MOTOROLA

Subject: Request for additional information regarding FCC ID: IHDT56GZ1

Correspondence Reference Number:	IHD0637
Confirmation Number:	1610060636/0638
Date of Original Email:	October 25, 2006

GSM 850 – Occupied Bandwidth – Channel 190 (836.6MHz) page 9

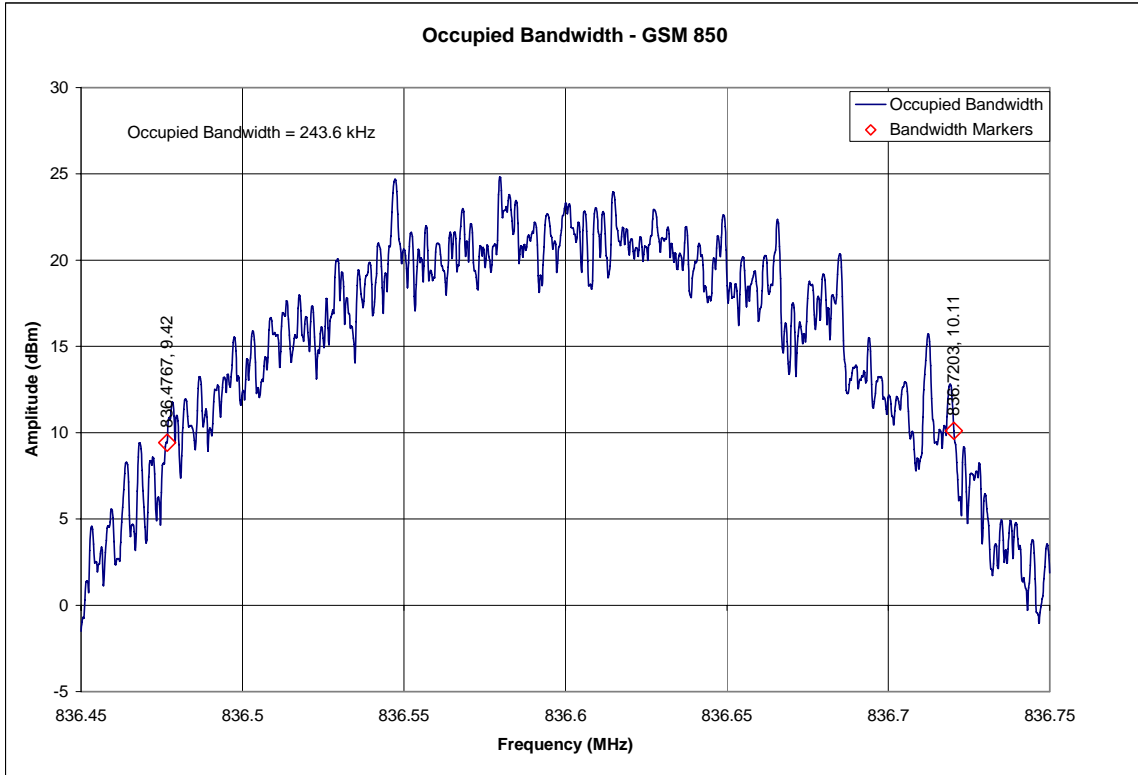
2. Please clarify occupied bandwidth data on Pages 9, 11, 13, and 15.

Response: Please refer to the following plots.
